## HEADLIGHT HOUSING MODIFICATION — 1981 FLH

The 1981 FLH model motorcycles, VIN 1HD 1ADK12BYO25631 through 1HD 1AKK25BYO38094, are equipped with a WASHER, Part No. 6718, under the risers to increase the clearance between the handlebars and the headlight housing. These motorcycles will require a modification to the headlight housing for some additional clearance.

### Figure 1. Modification Location

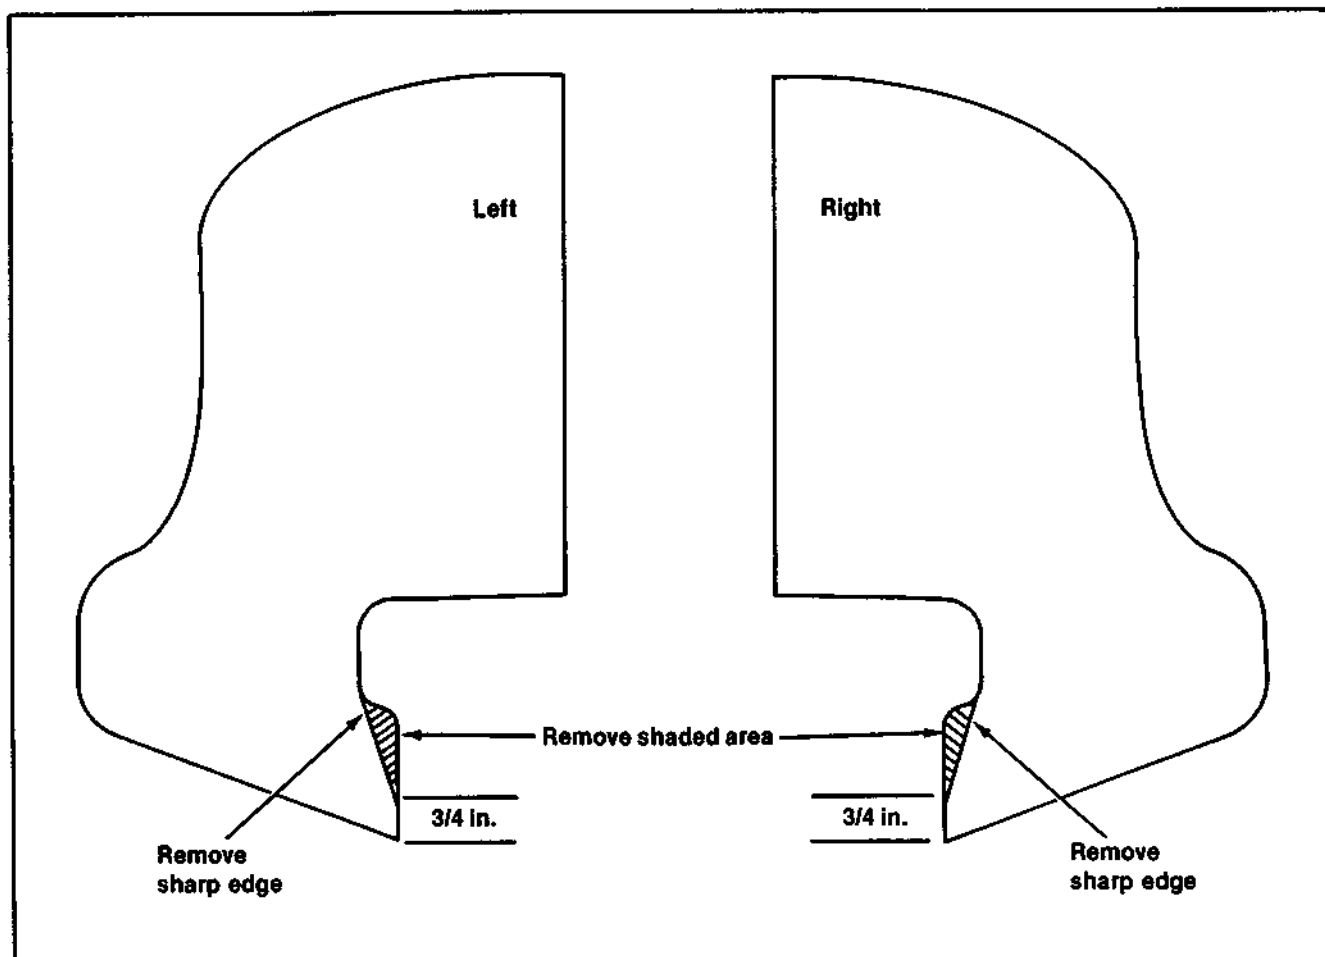
1. Remove the handlebar clamp cover and position the handlebars and wiring harnesses out of the way.
2. See Figure 1. Measure 3/4 in. forward from the back of the headlight housing along both sides of the open slot, in housing and place a mark on the housing.

3. See Figure 1: Remove (by grinding) 1/4 to 1/2 in. of metal material from the mark (made in Step 2) up to the round opening in the headlight housing.
4. Carefully clean all metal chips, produced during
